PRODUCT CHANGE NOTIFICATION

Bourns® Model SRN6045 Series Semi-shielded Power Inductors

Package Tape Carrier Modification

Current Package Tape

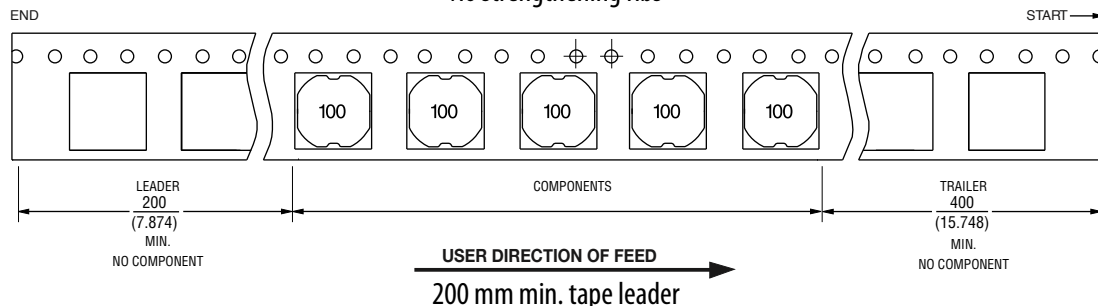
No strengthening ribs

Revised Package Tape

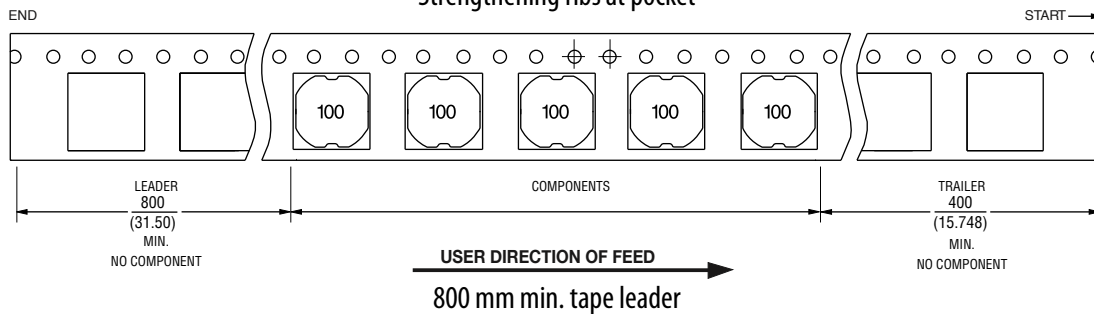
Riverside, California – July 27, 2021 – In the spirit of continuous improvement, effective January 22, 2022, Bourns will change the design of the package tape carrier for the [Model SRN6045 Series Semi-shielded Power Inductors](#). The design change will include strengthening the ribs to the carrier pocket to better protect the contained component from damage during freight transit and handling and lengthening of the tape leader. A list of affected part numbers follows.

Strengthening ribs at pocket

The form, fit and function of the inductor will not change as a result of these changes to the package tape carrier. The quality and reliability of the inductor should be improved with these changes to the package tape carrier.
